UNIVERSITY OF SOUTH CAROLINA CAPSTONE CAMPUS ROOM UPGRADES

PROJECT NO: 11103

ADDENDUM 02

March 16, 2012

3
1-7
CEILING DETAIL
SCALE: 1 1/2" = 1'-0"

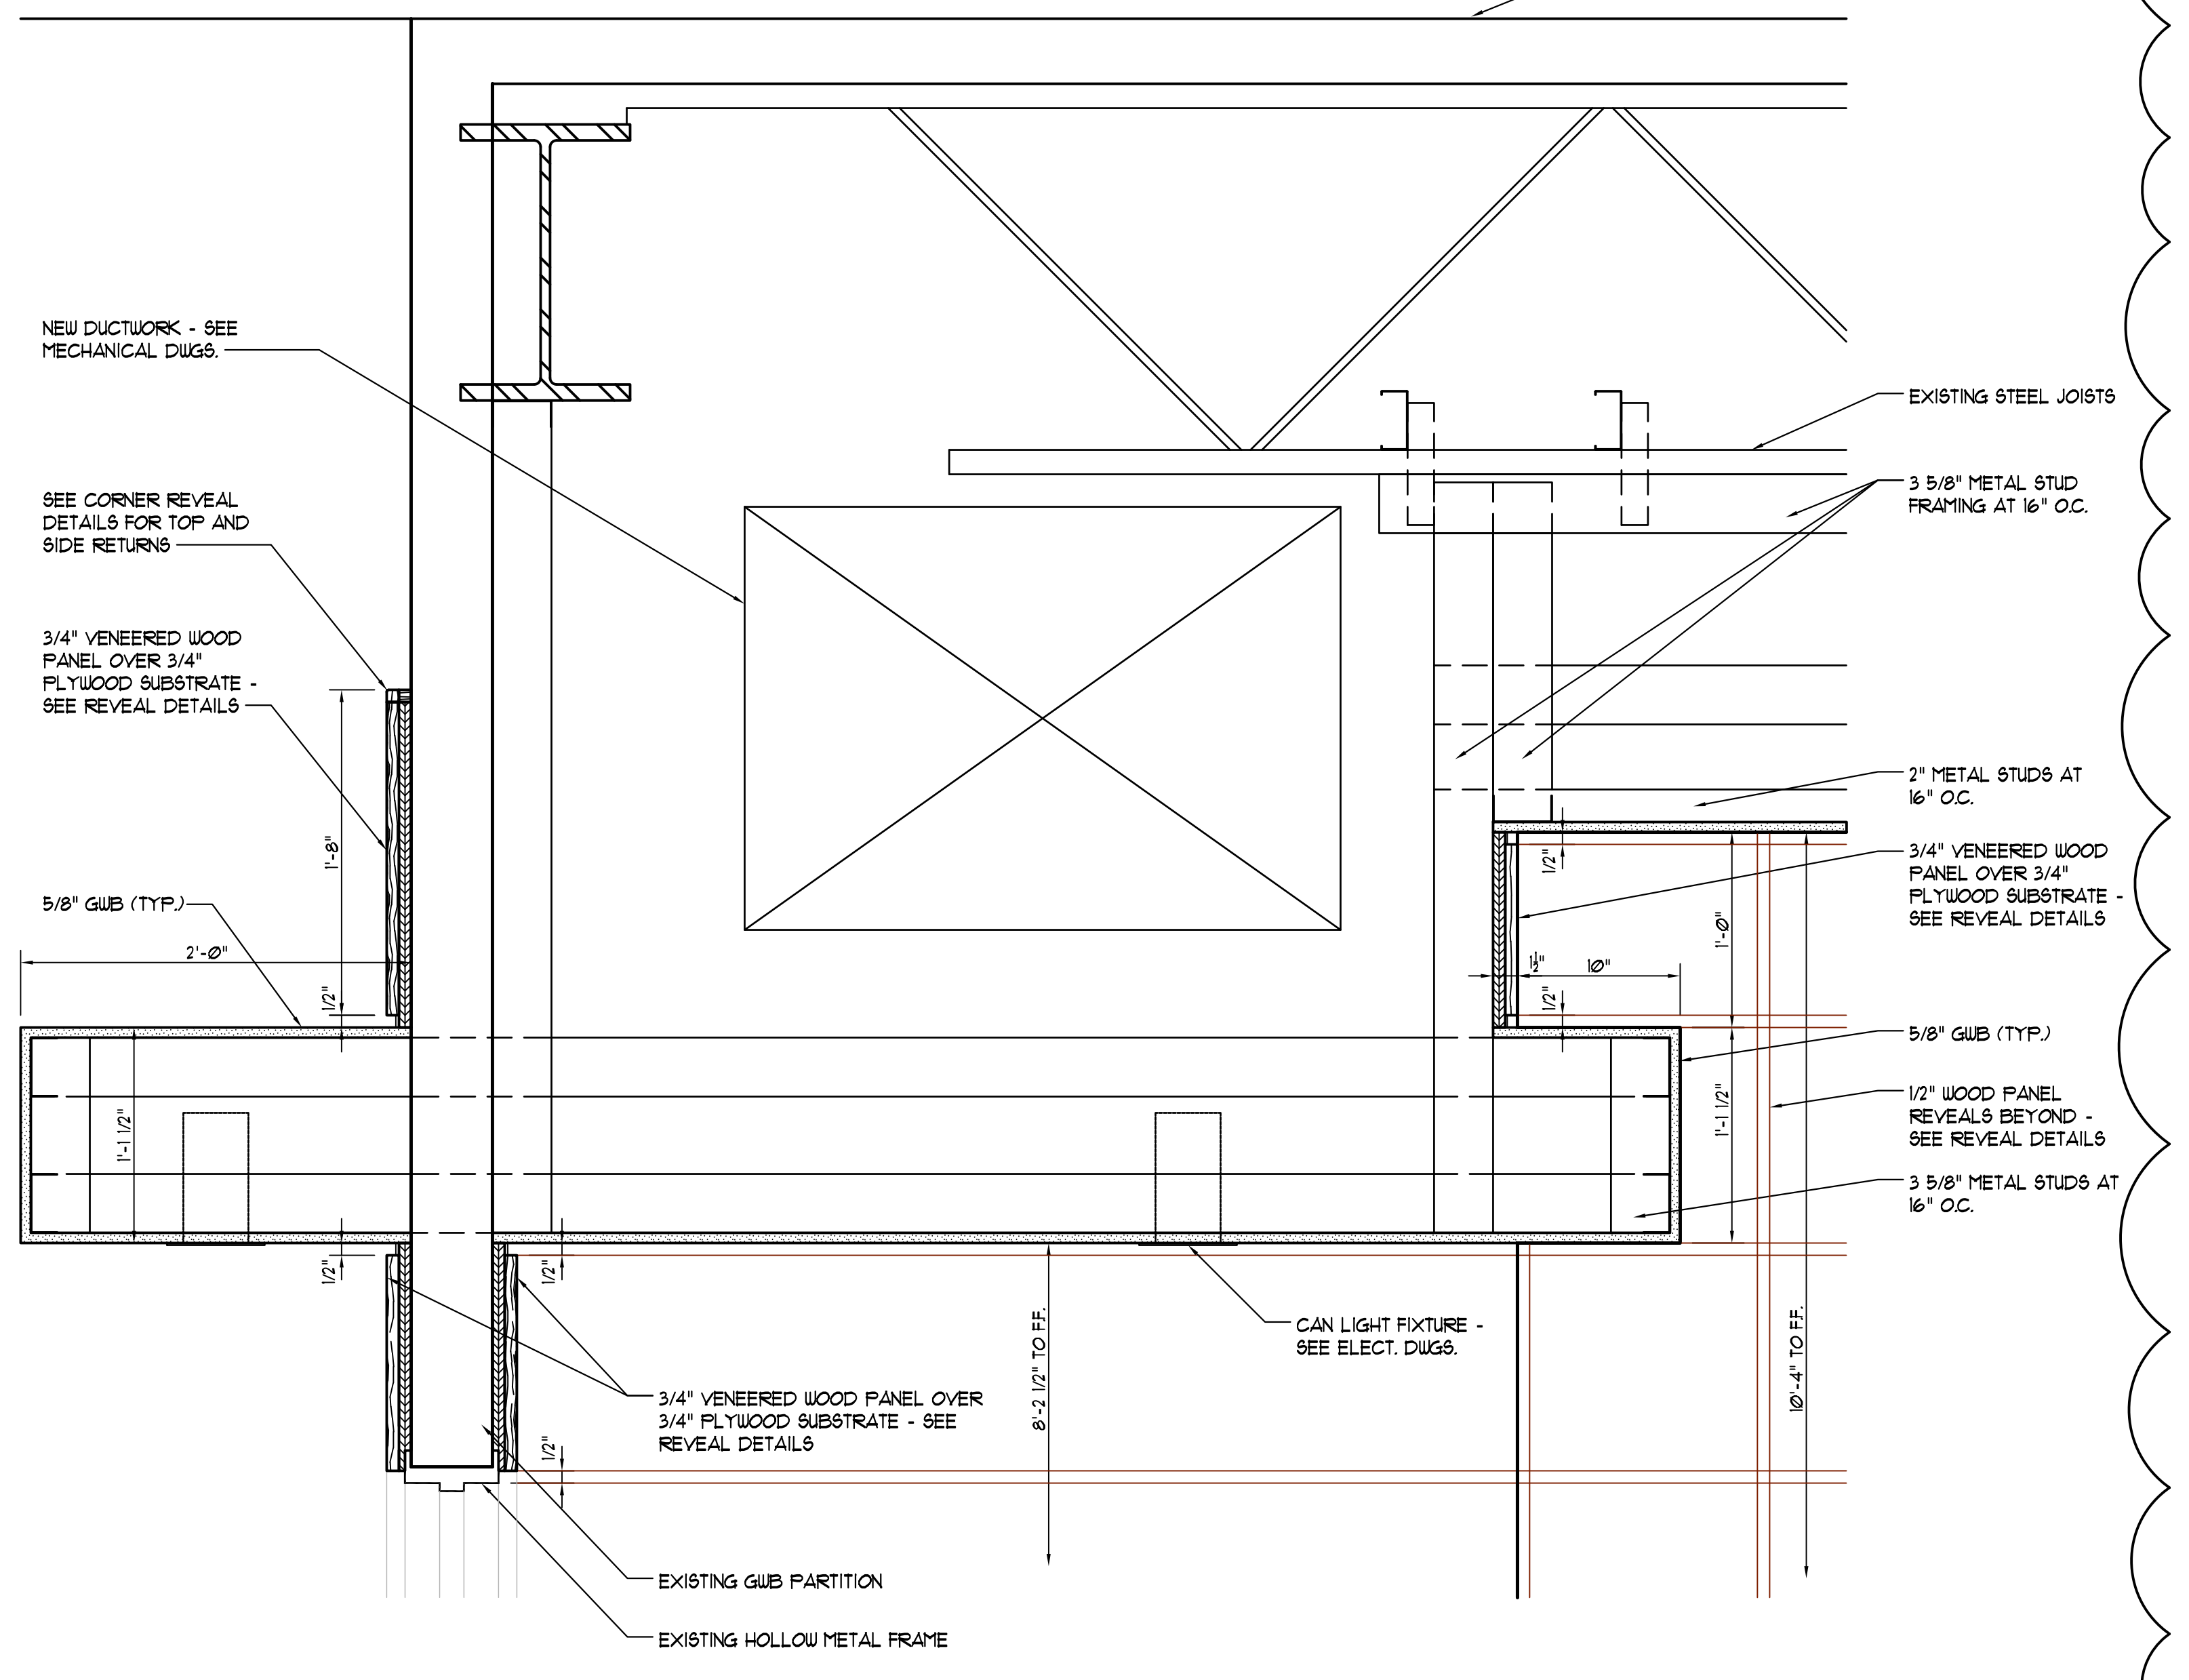
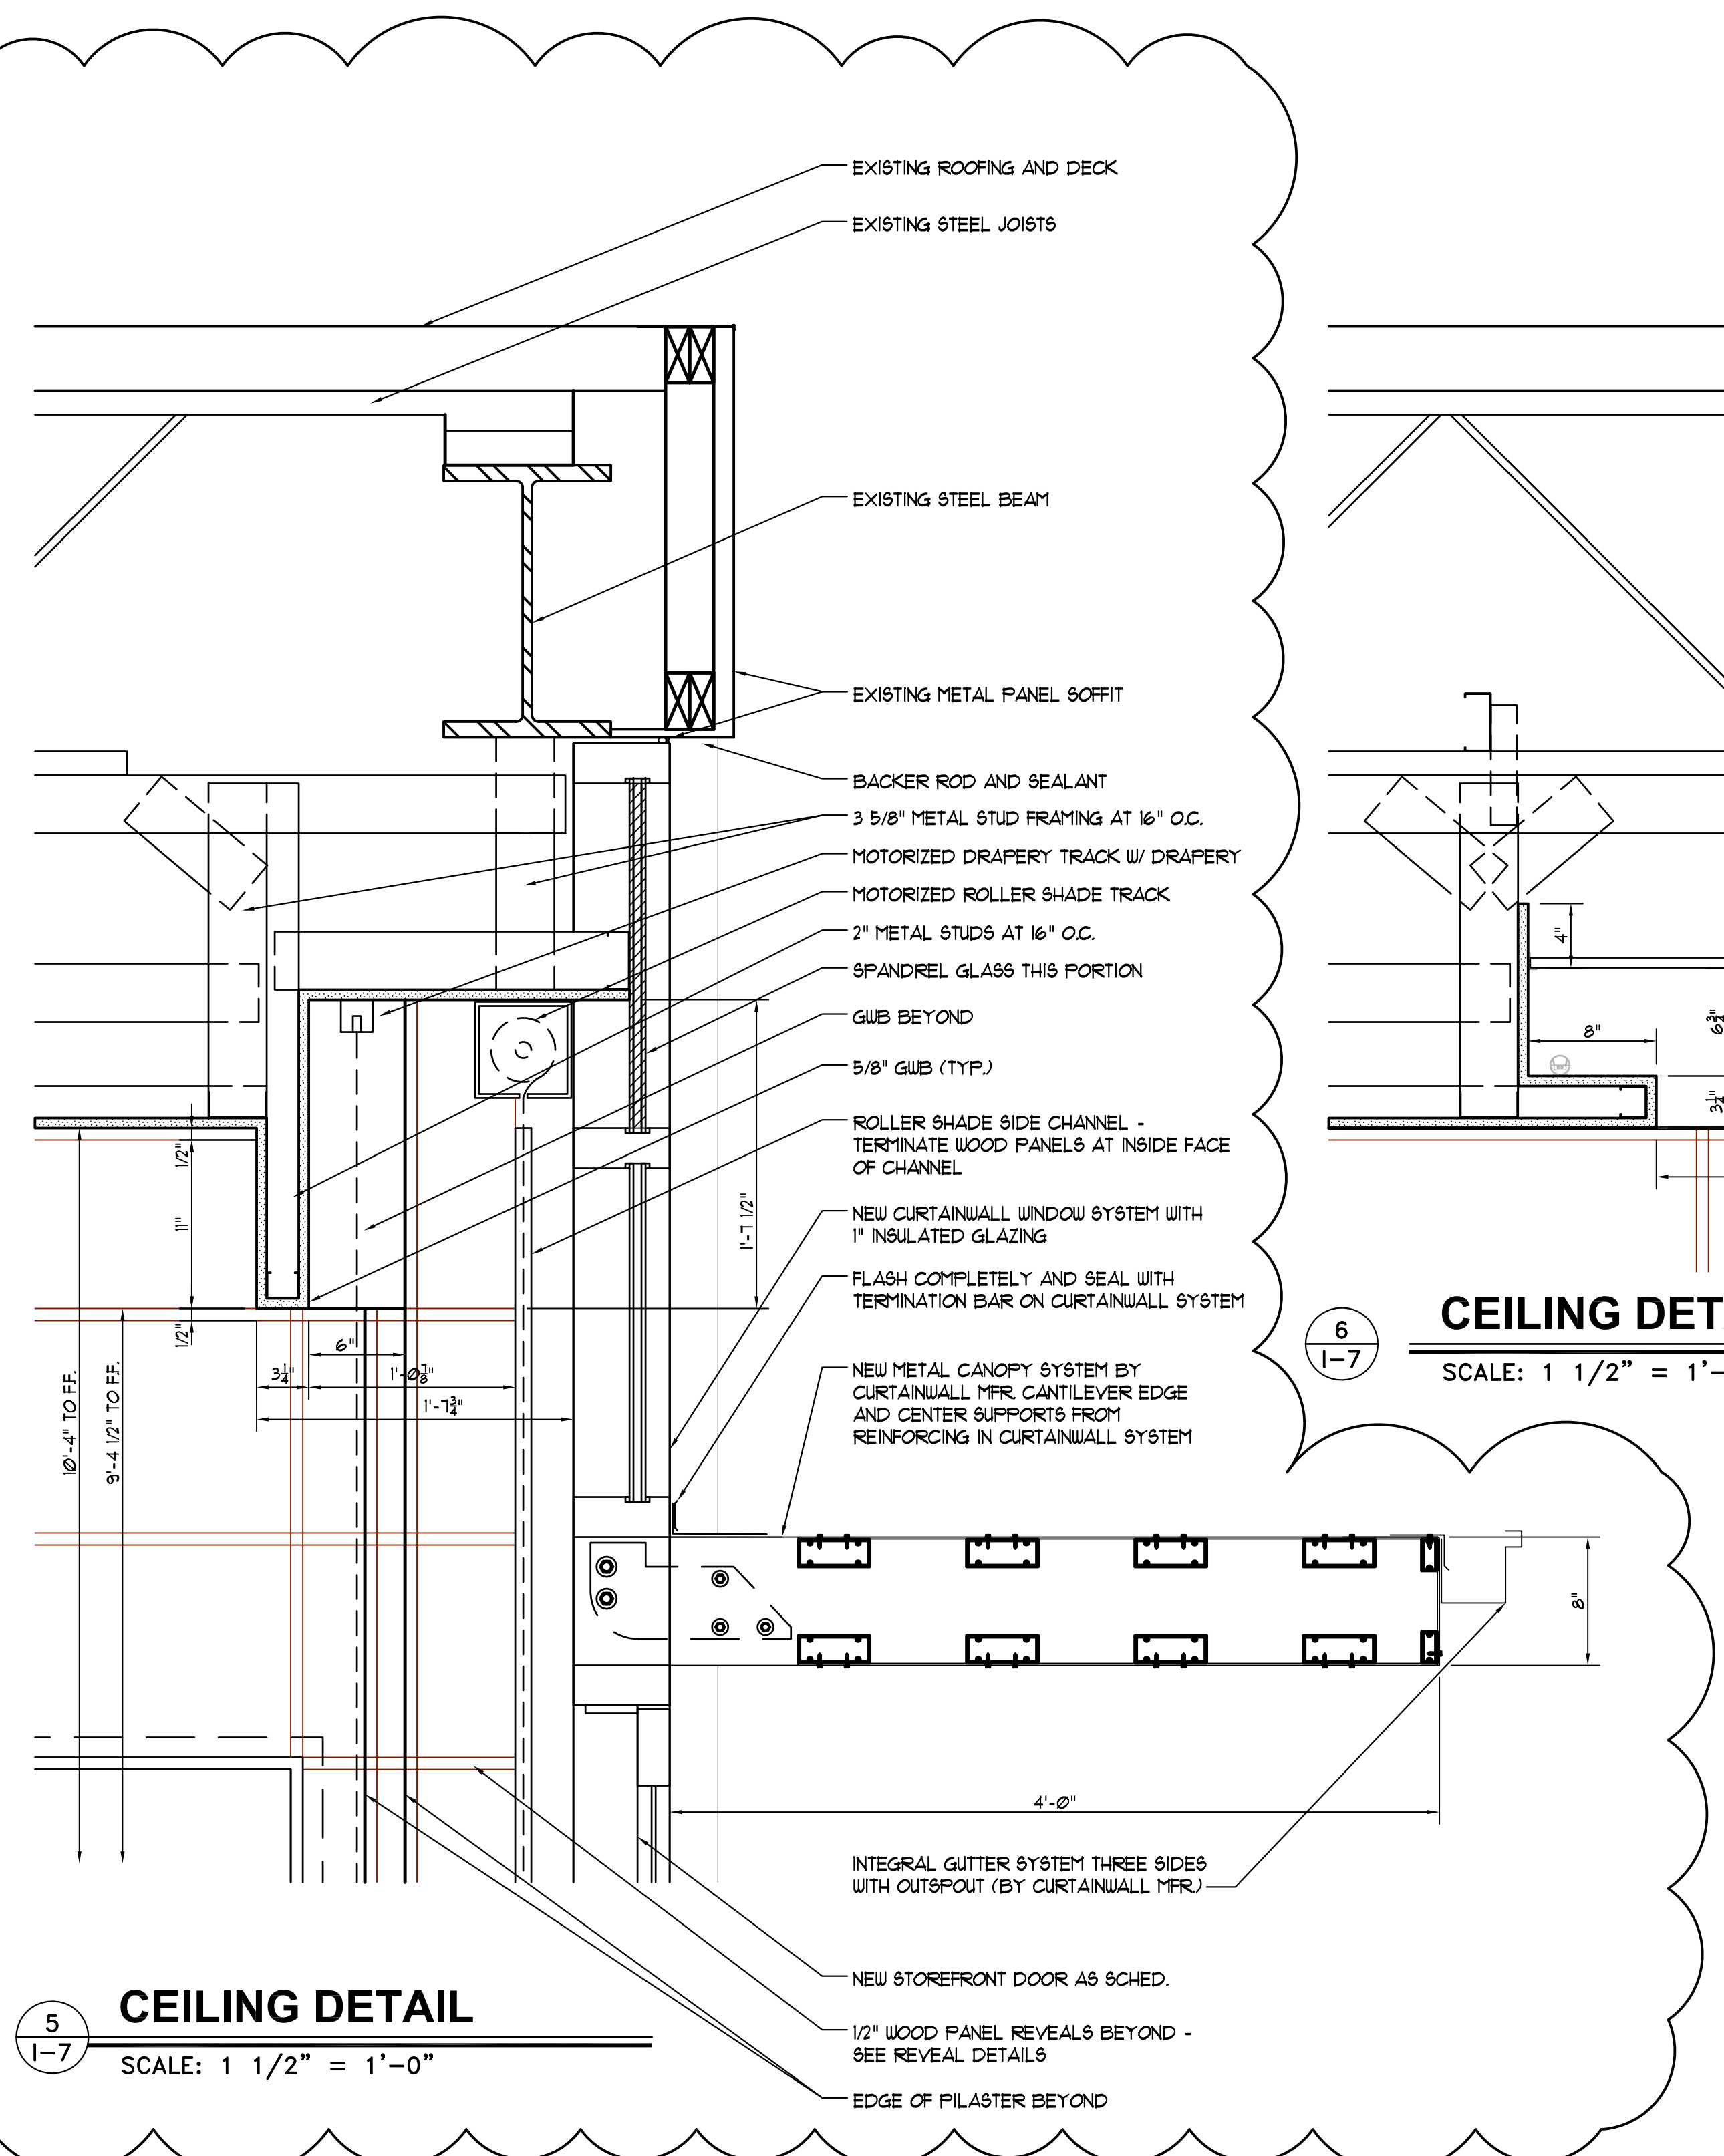
1. **Drawing I-7 CEILING DETAILS:** OMIT Drawing I-7 and **REPLACE** it with NEW DRAWING I-7.
2. **Drawing I-5 DOOR & FINISH SCHEDULES / COLOR SCHEDULE / DOOR & WINDOW TYPES & DETAILS / PANEL DETAILS:** CHANGE Wood Veneer Panel Reveal Details as shown.
